# STERLING RANCH FILING NO. 4

## A REPLAT OF LOTS 22-32 & TRACTS B & J, STERLING RANCH FILING NO. 2 &

# Final Plat Drawings\_v2.pdf Markup Summary 1-3-2023

JOB NO. 25188.11  
 NOVEMBER 29, 2022  
 SHEET 2 OF 6

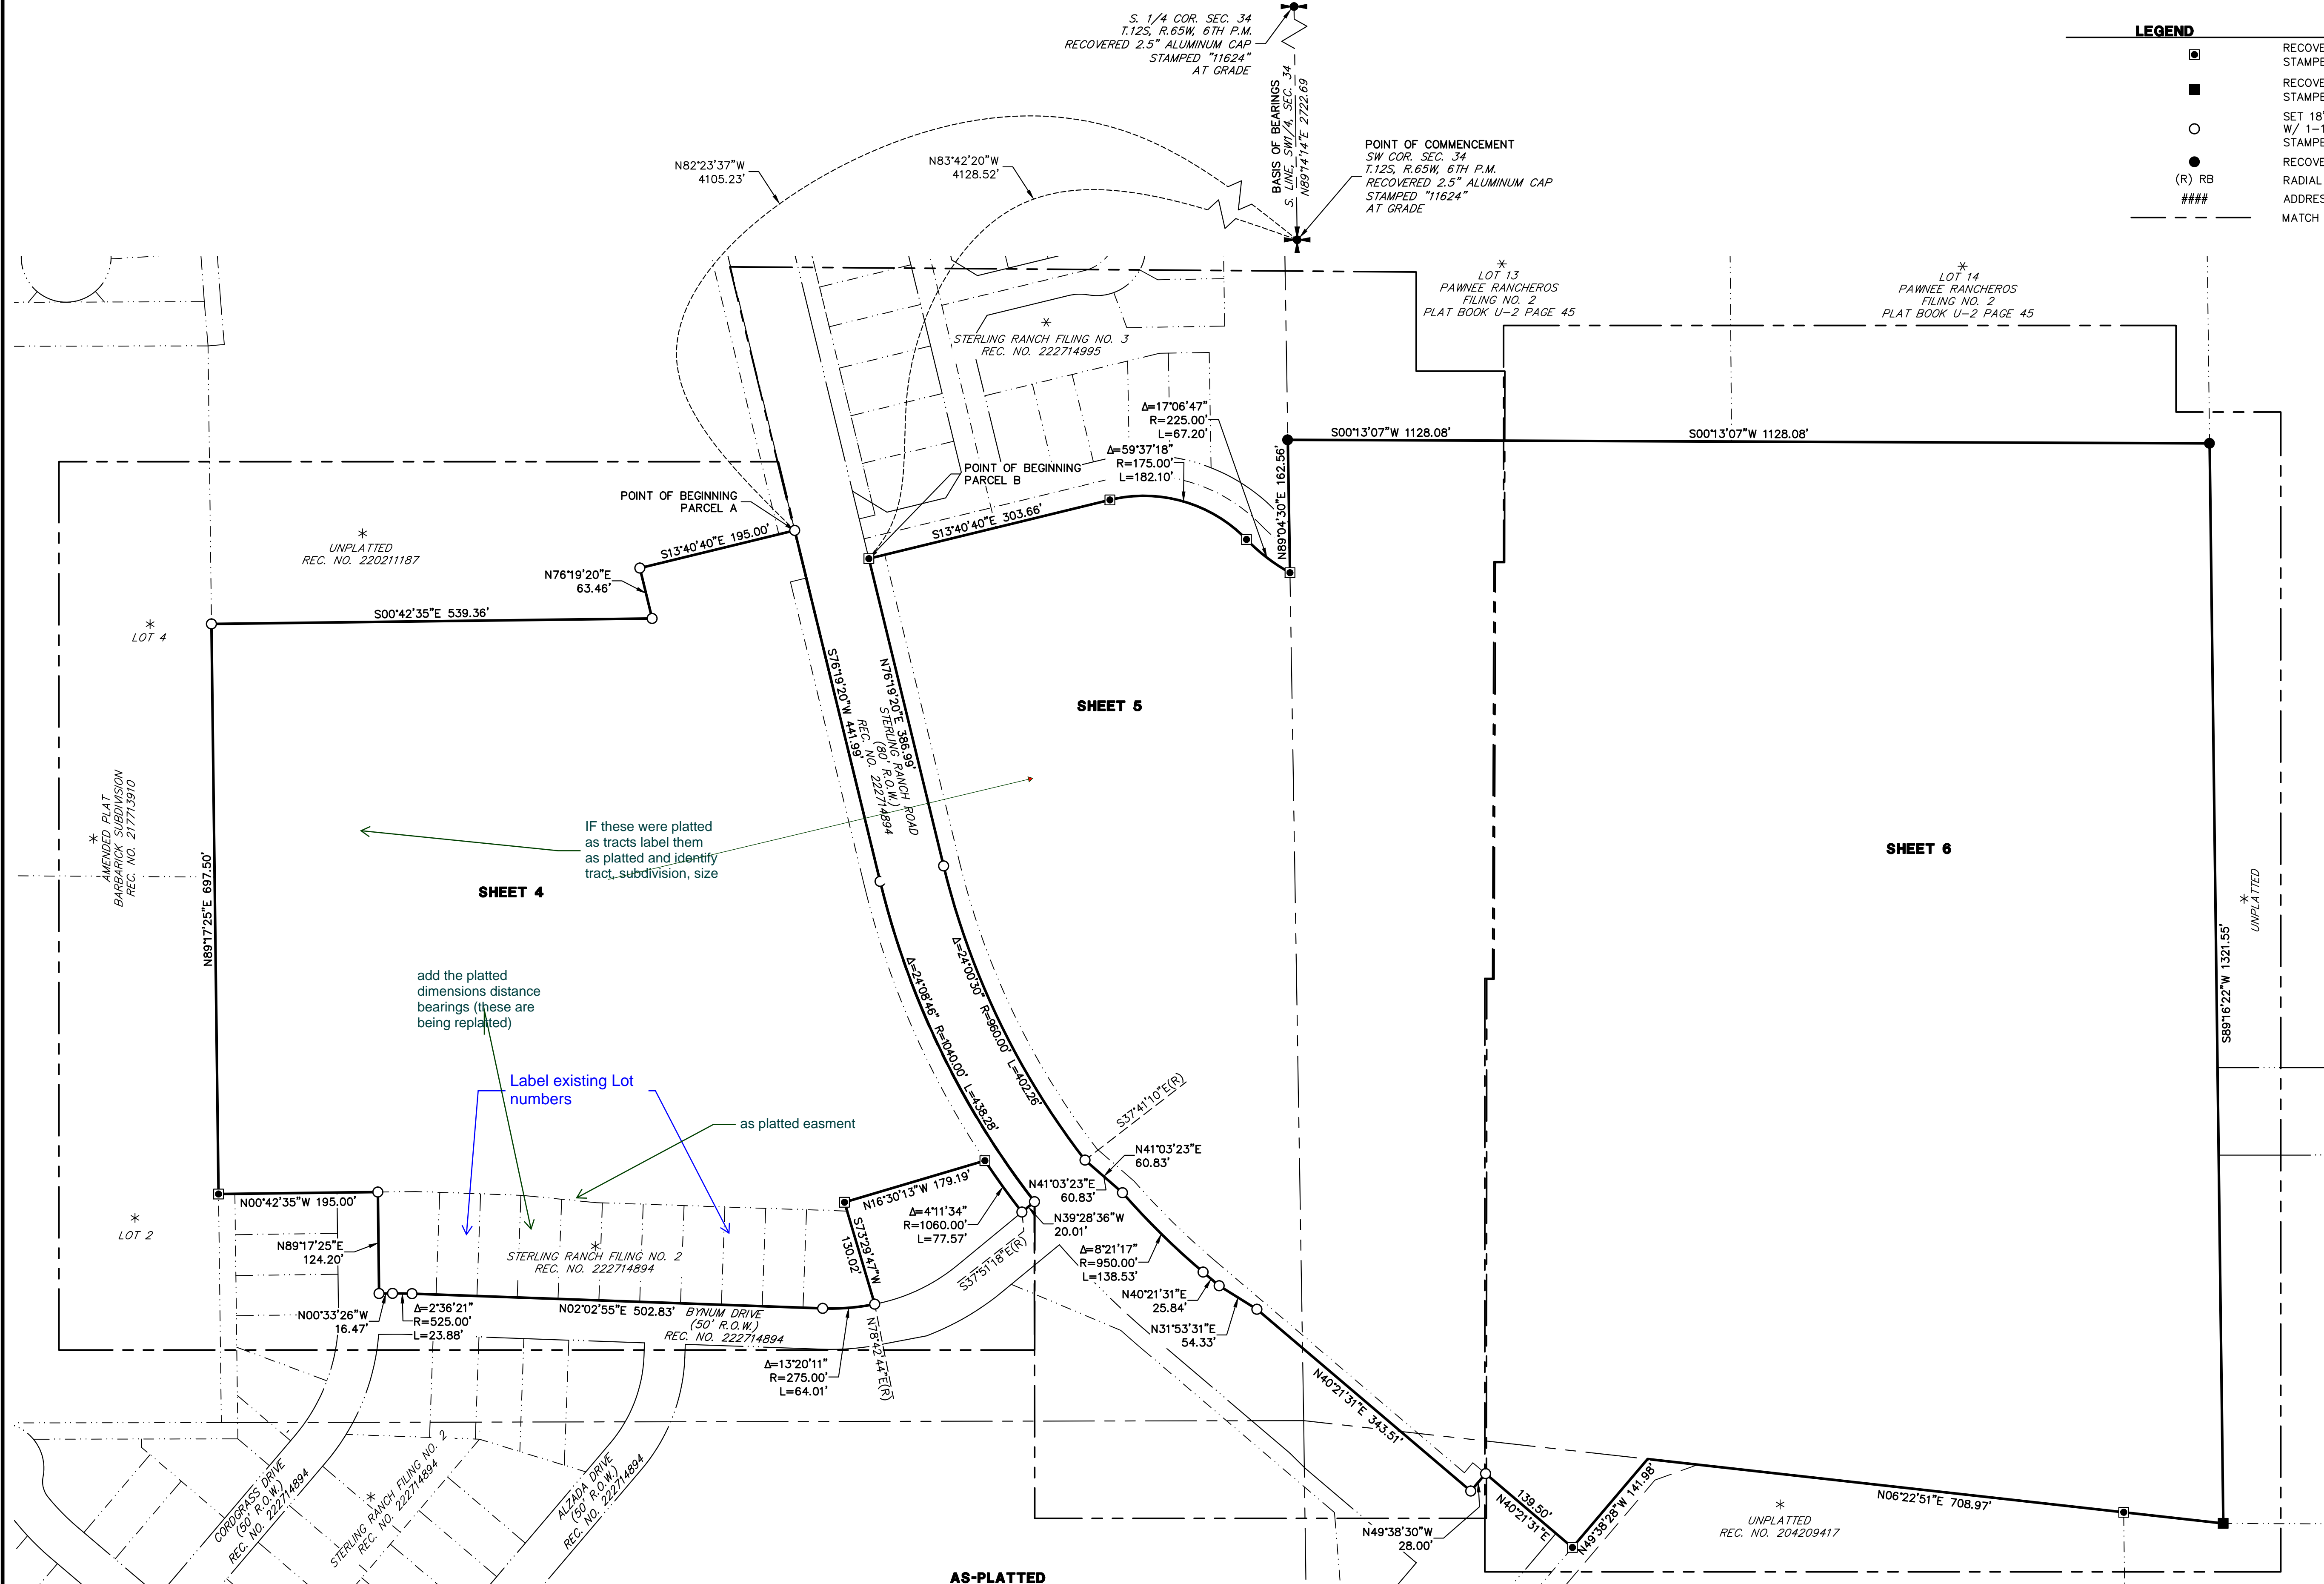
Provide maintenance entity for the sewer underdrain system.

Provide maintenance entity for the sewer underdrain system.

JOB NO. 25188.11  
 NOVEMBER 29, 2022  
 SHEET 4 OF 6

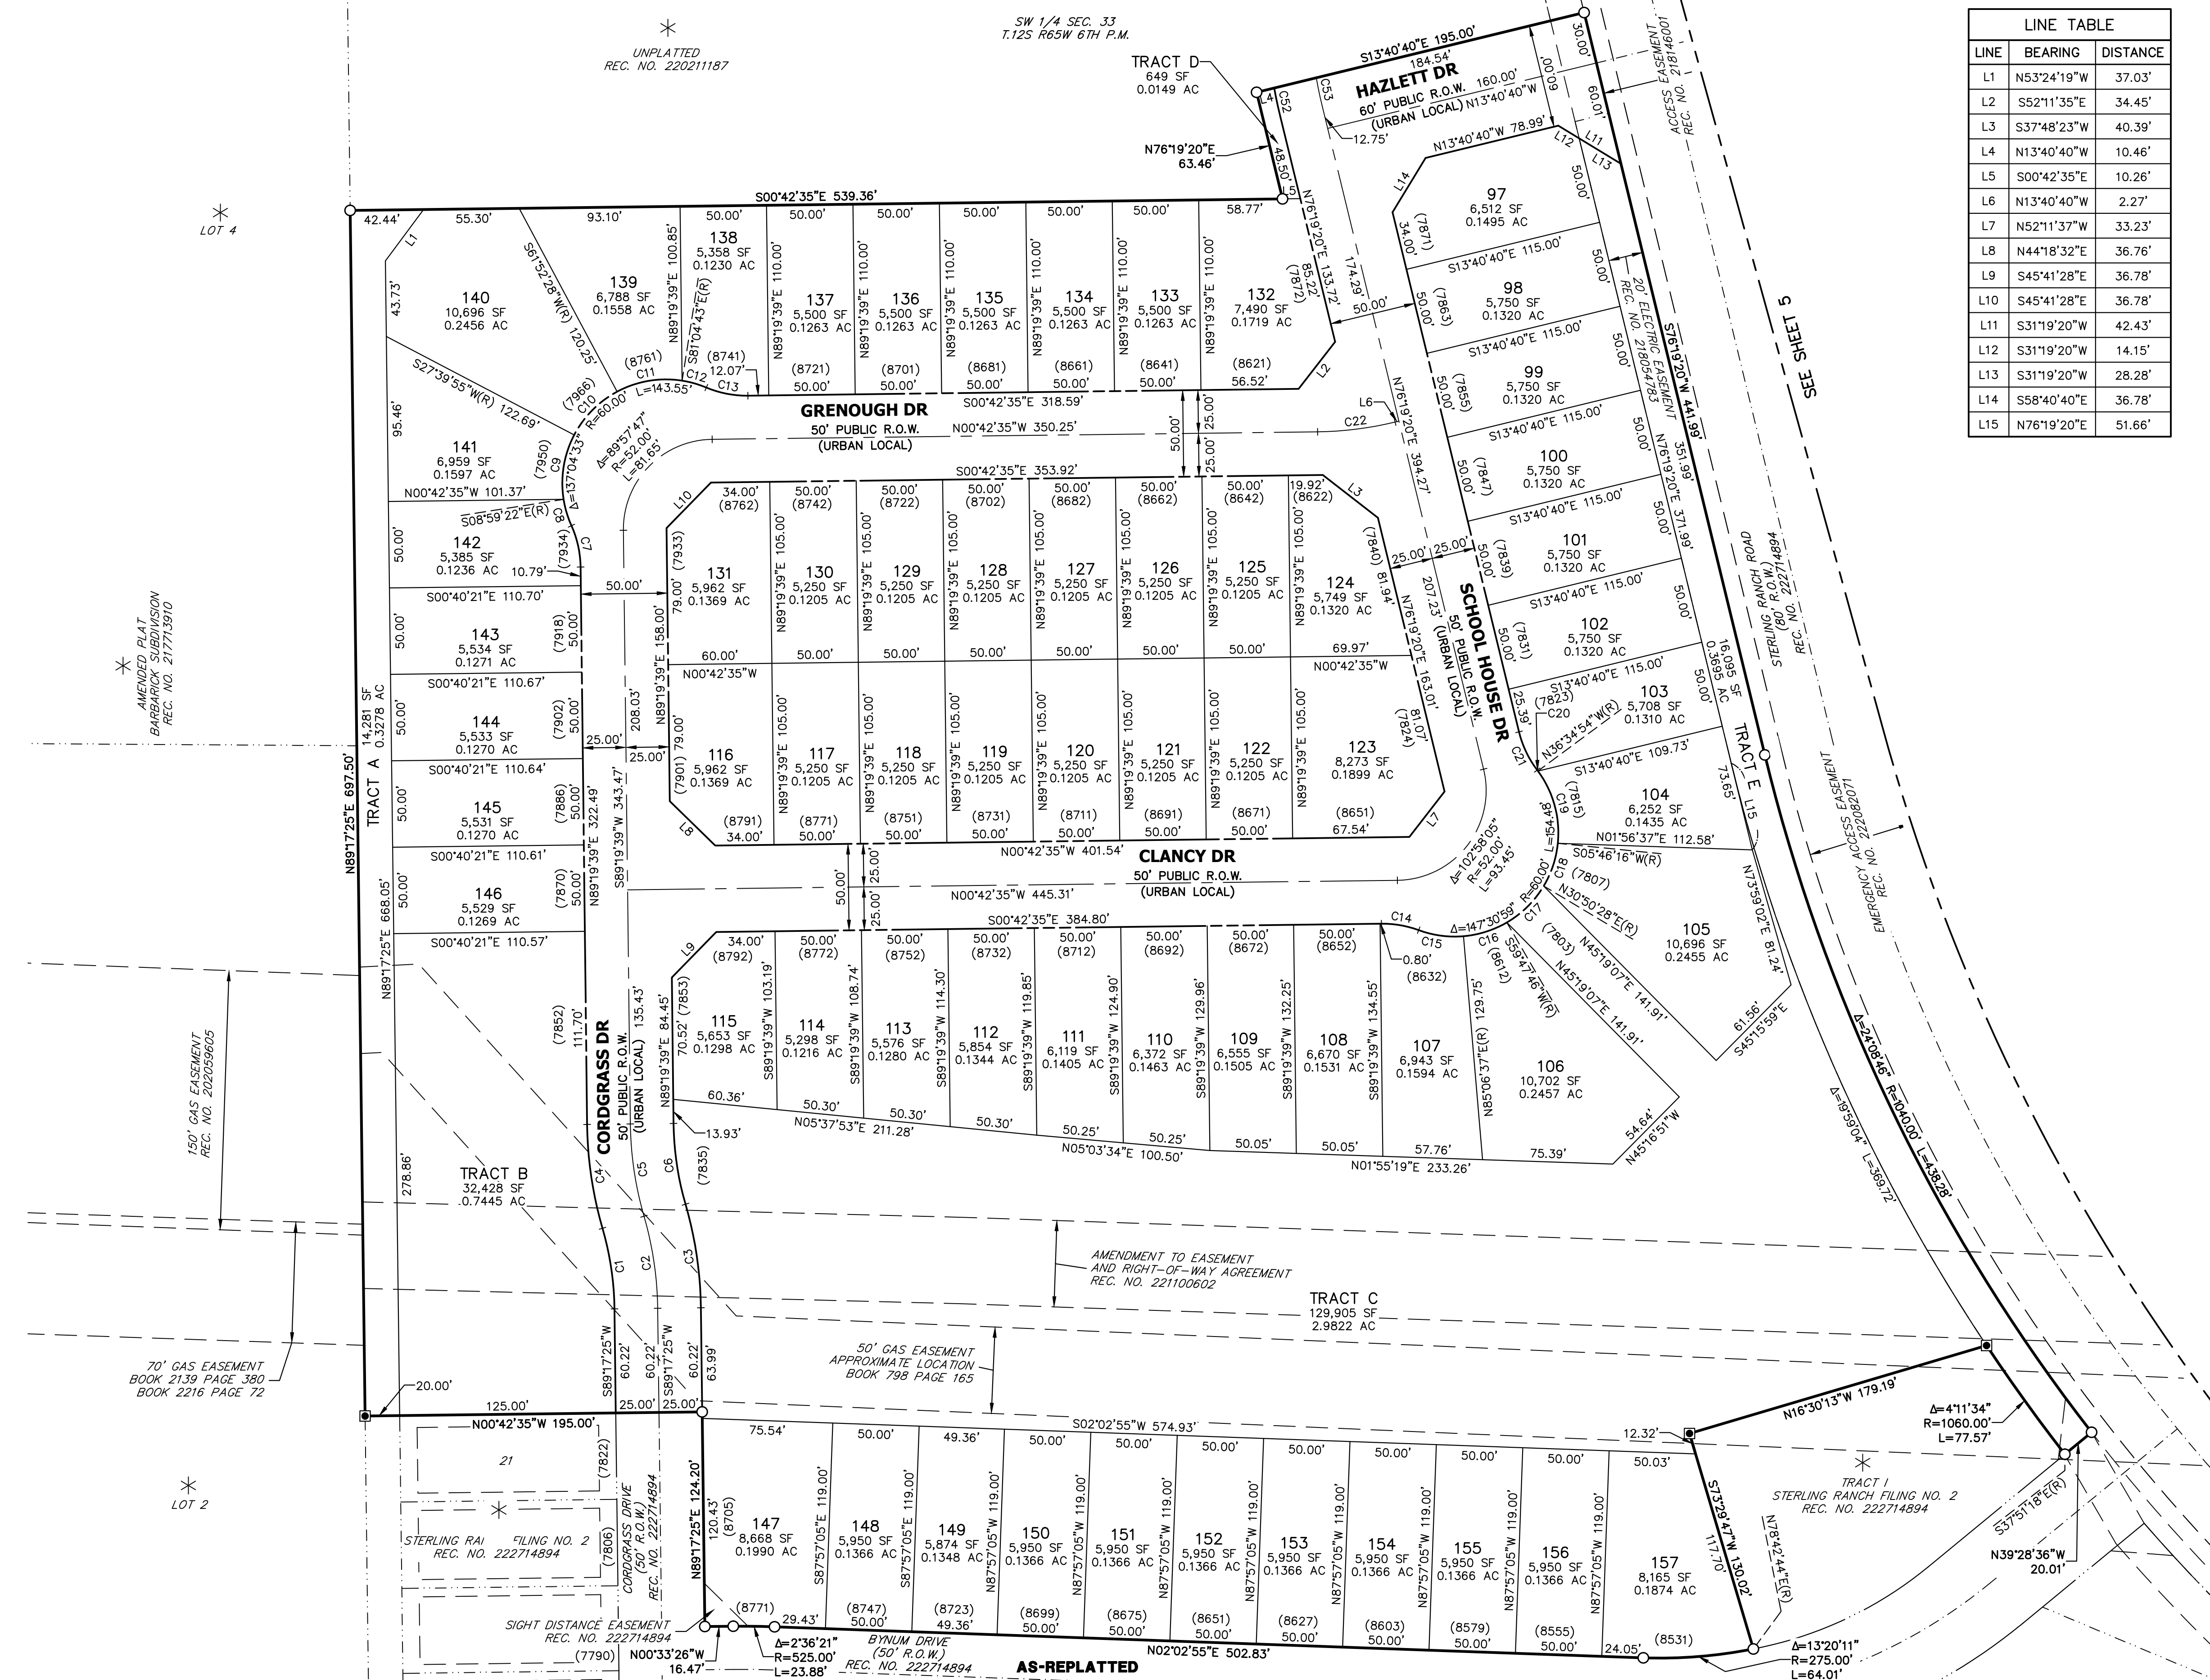
Will there be a waiver for 30' frontage requirement?  
 Address in LOI.

Will there be a waiver for 30' frontage requirement? Address in LOI.

JOB NO. 25188.11  
 NOVEMBER 29, 2022  
 SHEET 6 OF 6

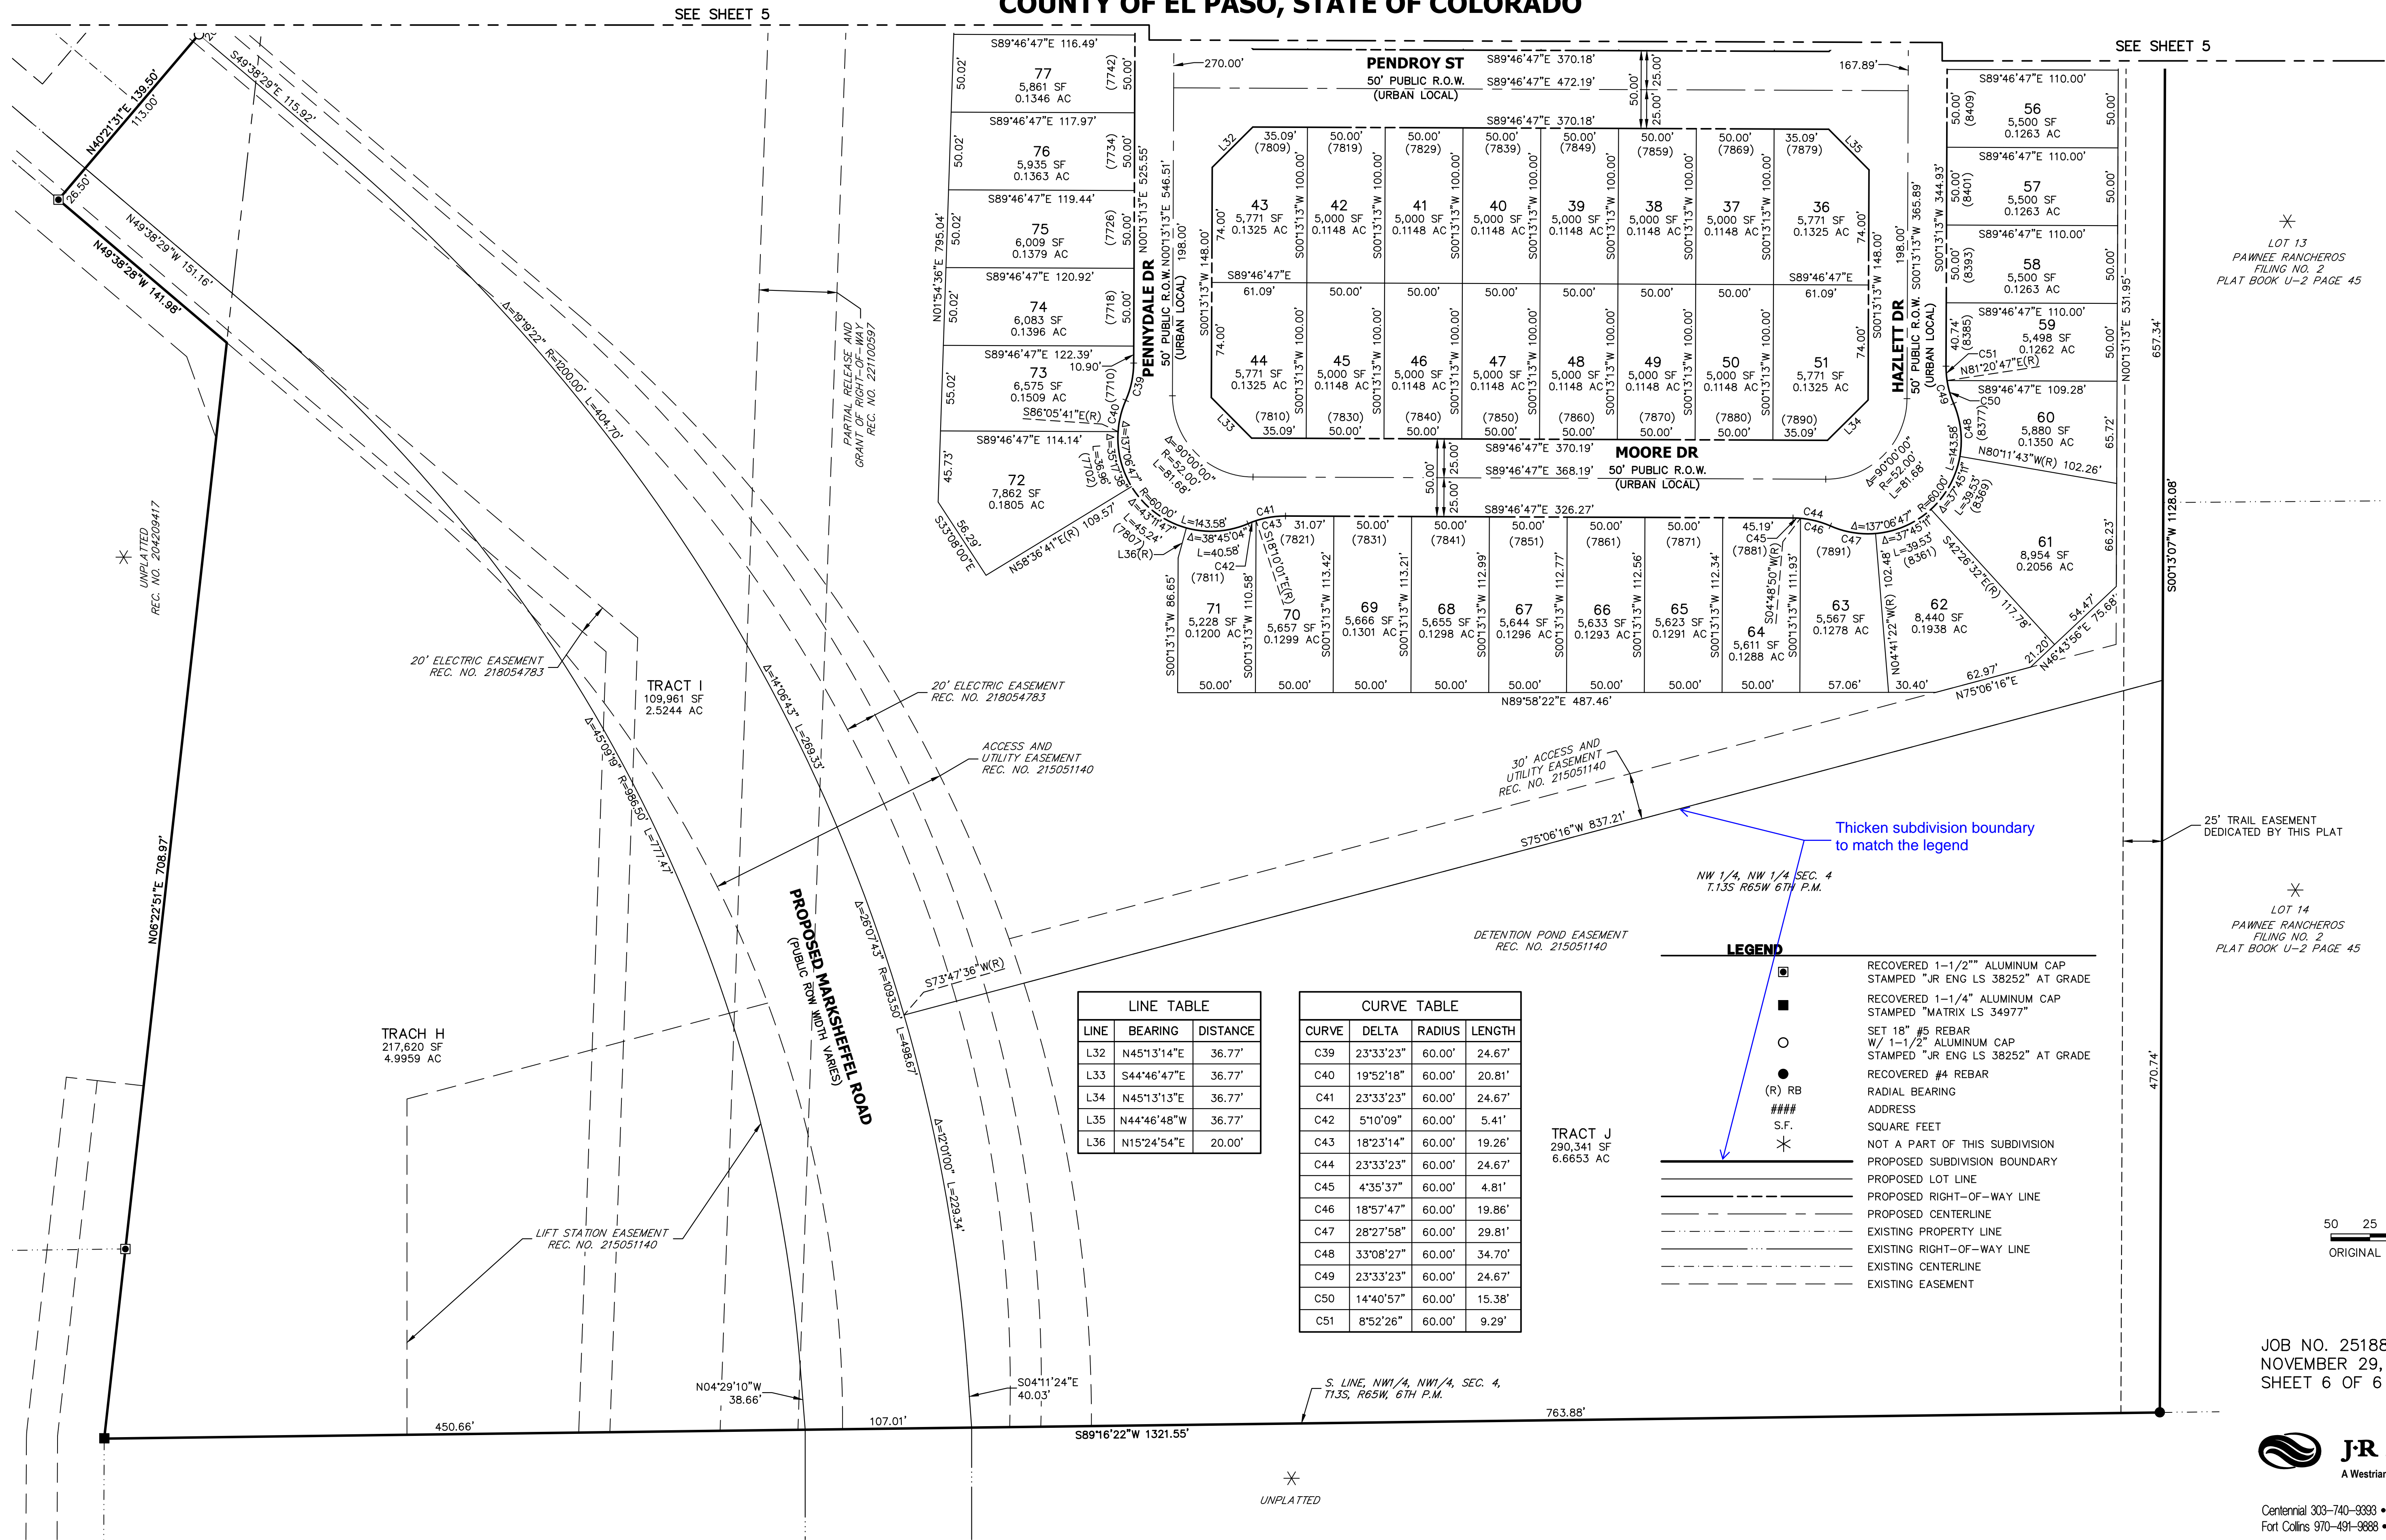
Thicken subdivision boundary to match the legend
